Service Bulletin

Bulletin SB 2016
(Same as SB-059)

SUBJECT: DC Voltage Protection Circuit for KR-5400, KR-4400, and KA-4006

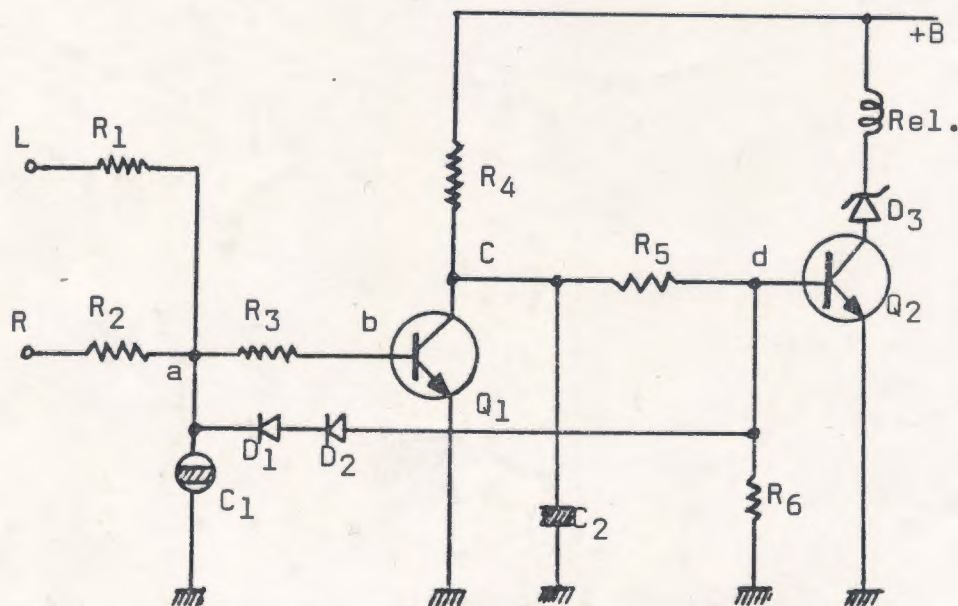
A production change has resulted in the use of a new DC voltage protection circuit in the KR-5400, KR-4400, and KA-4006. The change applies to those units of the above model whose serial numbers are 06XXXX or higher.

The basic circuit layout for the new protection circuit and a brief description of its operation is provided below:

- 1) Left channel output signal (or R-Ch output signal) is applied to point "a" through R1 (or R2).
- 2) AC output signals are bypassed via C1 to ground and do not activate the circuit.
- 3) If a positive DC voltage appears at "a", this voltage is applied to the base of Q1 (point "b") through R3.
Because of the increased base voltage Q1 is turned on and the Q1 collector voltage decreases. As a result, the voltage at "d" also decreases and Q2 is turned off.
- 4) If a negative DC voltage appears at "a", this voltage appears at "d" through D1 and D2, so that Q2 is turned off.
- 5) R4 and C2 have a time constant. Therefore, there is a time delay after the power switch is turned on until the relay closes.
- 6) D3 (Zener Diode) improves the switching characteristic of Q2 and allows a quicker release of the relay when the power switch is turned off.
